# RENAULT SPORT

## Technical Bulletin N°3

REFERENCE	BT_2011_FR20_3_UK
DATE	1st February, 2011
SUBJECT	Pagid brake pads, engine cover allowed modification, engine rebuilding modification
PART	Brake pads, engine cover, engine

#### 1. New brake pads

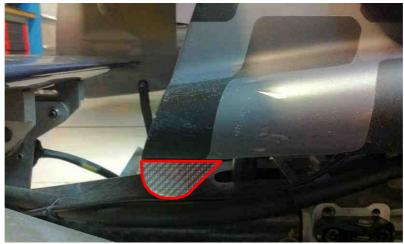
A new type of brake pad is introduced for 2011 season. These specific brake pads from Pagid are now available from your Renault Sport spare parts department under the reference 77 11 166 677.

The brake behaviour is slightly different from the Ferodo brake pads and their lifetime is longer.

**Note:** only Ferodo (ref. 77 11 166 277) and Pagid (ref. 77 11 166 677) brake pads proposed by Renault Sport will be allowed for 2011 season. They come with a specific marking.
